GOVERNMENT OF INDIA
MINISTRY OF COMMUNICATIONS
CIVIL AVIATION DEPARTMENT

NOTICES
TO
**AIRCRAFT OWNERS AND
GROUND ENGINEERS**

NOTICES TO AIRCRAFT OWNERS AND GROUND
ENGINEERS, 1930-1948.

FIG. 2

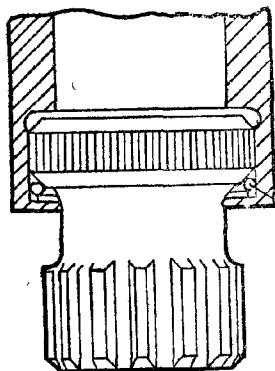
It has been found necessary to strengthen the engine to constant speed unit drive coupling as service experience has shown that under certain operational conditions the drive shaft and coupling serrations are subject to abnormal wear. It is essential therefore that operators carry out the undermentioned inspection procedure pending the introduction of re-designed parts; the design and testing of which is in hand. All operators will be notified of the modification action to be taken when the new parts are available.

1. After first 100 hours flying of the constant speed unit from new or after overhaul, and as soon as possible on those which have already exceeded 100 hours flying.
 - (a) Remove the constant speed unit from the engine.
 - (b) Remove circlip P21684 and coupling, and after cleaning with petrol examine serrations carefully both in the drive shaft bore and on the coupling. It is advisable that a magnifying glass is used as the wear is not always discernible to the naked eye. The form of this wear is illustrated in the accompanying sketch (Fig. 1).
 - (c) Excessive wear to either the drive shaft or coupling serrations will necessitate the c.s. unit being returned for overhaul.
 - (d) If the serration form is not unduly worn, the coupling may be reassembled and retained by circlip P21684, which must be replaced if damaged.

FIG. 3.

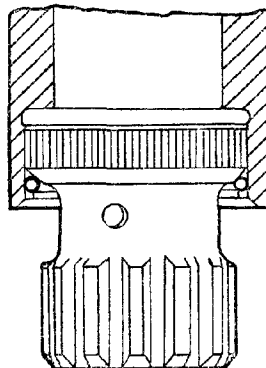
Note: Coupling P24519/1 (Fig. 3) as introduced by Modification C153 for PAY 5100 units and Modification C146 for CAY 5100 differs from coupling P24519 by the addition of a pin through the wasted portion. Where this coupling is used it is not possible to obtain maximum serration engagement unless it is supported in the bore of constant speed unit drive shaft by circlip P25787 as illustrated in Fig. 4. The introduction of this circlip is covered by Modification C207 for PAY 5100 units and C206 for CAY 5100 units and it is essential that the fitment of this circlip be checked irrespective of the modifications appearing on the constant speed unit history plate. Circlips P25787 and coupling retention circlips P21684 will be supplied free of charge on application to the Service Manager, De-Havilland Propellers Ltd., Hatfield, Hertfordshire, England.
